UNITED STATES PATENT AND TRADEMARK OFFICE

APPLICATION NO.	FILING DATE	FIRST NAMED INVENTOR	ATTORNEY DOCKET NO.	CONFIRMATION NO.
10/637,929	08/07/2003	Chien-Kuo Chang	13880 B	1946

Office Action Summary

DETAILED ACTION***Drawings***

Gigante
Fig. 2

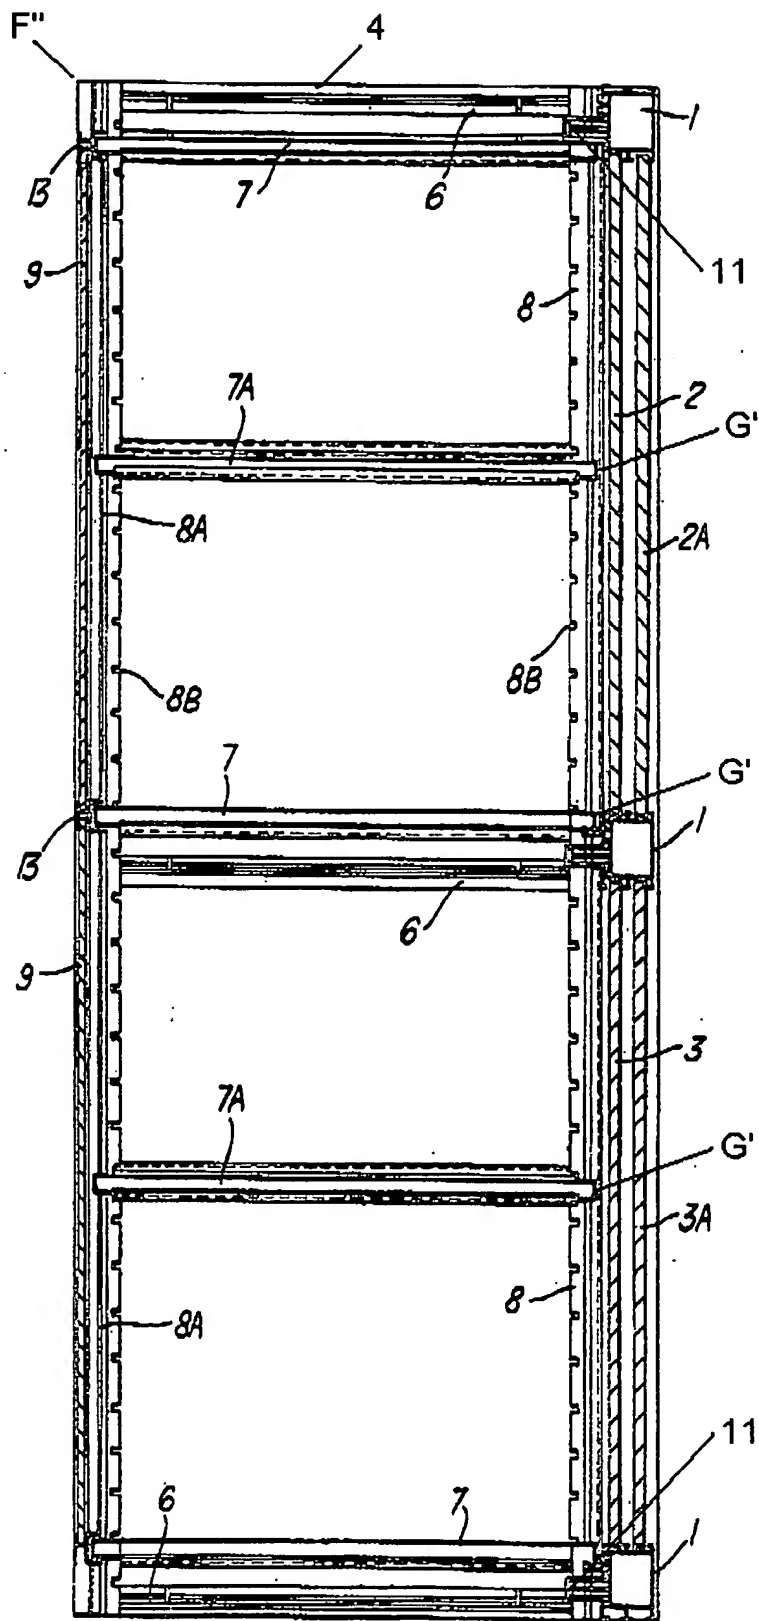
11. Regarding claim 1: In Fig. 1, Gigante shows a shelving unit comprising: a plurality of supporting frame bars arranged in parallel (F', F'', F'''). In Fig. 2, Gigante shows a cross section of a shelving unit including supporting frame bars (F'') each comprising an elongated vertical frame portion (8A), an elongated top horizontal frame portion (6) perpendicularly extended from the top end of the elongated vertical frame portion (8A), and an elongated bottom horizontal frame portion (6) perpendicularly extended from the bottom end of the elongated vertical frame portion (8A) and disposed in parallel to the elongated top horizontal frame portion (6), a back panel (9) fastened to the elongated vertical frame portions (8A) of the supporting frame bars (F'') and supported between the elongated top horizontal frame portions (6) and elongated bottom horizontal frame portions (6) of the supporting frame bars (F''), a bottom panel (7) fixedly fastened to the elongated bottom horizontal frame portions (6) of the supporting frame bars (F''), a front open frame (1) fixedly fastened to the free ends of the elongated top horizontal frame portions (6) and elongated bottom horizontal frame portions (6) of the supporting frame bars (F'') and disposed in parallel to the back panel (9),

the front open frame (1) having a plurality of locating grooves (G'), a plurality of partition board holders (13) fixedly fastened to the back panel (9) and horizontally aligned in a line, a top panel (4) fixedly fastened to the elongated top horizontal frame portions (6) of the supporting frame bars (F') and maintained in parallel to the bottom panel (7), and a plurality of partition boards (7) respectively engaged into the locating grooves (G') of the front open frame (1) and the partition board holders (13) and spaced between the top panel (4) and the bottom panel (7).

13. Regarding claim 6: In Fig. 2, Gigante shows a shelving unit, wherein the supporting frame bars (F'') each have at least one horizontal mounting lug (11) respectively provided at the free ends of the respective elongated top horizontal frame portions (6) and elongated bottom horizontal frame portions (6).

14. Regarding claim 7: In Fig. 2, Gigante shows a shelving unit, wherein the front open frame (1) is fixedly fastened to the horizontal mounting lugs (11) of the supporting frame bars (F'').

15. Regarding claim 9: In Fig. 2, Gigante shows partition board holders (13) comprising U-shaped clamps (13) fixedly fastened the back panel (9) by fastening elements (13).

FR-1,143,195-A

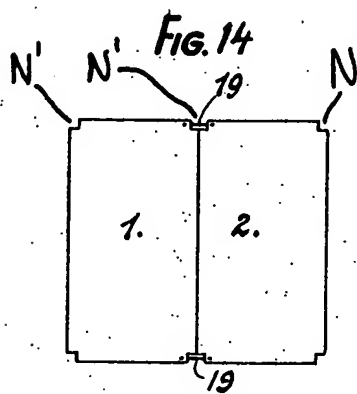
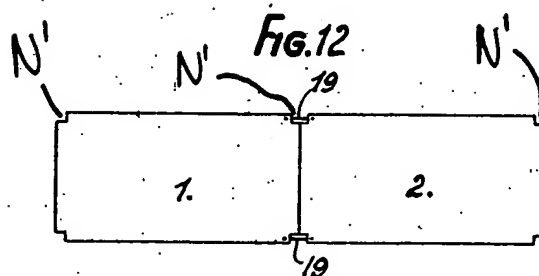
1,143,195-A). In Figs. 1 and 2, Gigante shows a shelving unit with all the aspects described in claim 1 and 2. In Fig. 2, Gigante shows a cross section of a shelving unit including the supporting frame bars (F'') each comprising an elongated vertical frame portion (8A), an elongated top horizontal frame portion (6) perpendicularly extended from a top end of the elongated vertical frame portion (8A), and an elongated bottom horizontal frame portion (6) perpendicularly extended from bottom end of the elongated vertical frame portion (F'') and disposed in parallel to the elongated top horizontal frame portion (6), but lacks a back panel with a plurality of top notches respectively disposed in a top side thereof and adapted to receive the elongated top horizontal frame portions of said left, right and middle supporting frame bars respectively. In Fig. 12, the French document teaches a panel with a plurality of top notches (N') respectively disposed in a top side thereof and adapted to receive frame members (19). It would have been obvious to one skilled in the art at the time of invention to utilize the back panel with a plurality of top notches of the French document to receive the elongated top horizontal frame portions of the left, right and middle supporting frame bars of Gigante to allow the back panel to extend past the elongated top horizontal frame bars portions.
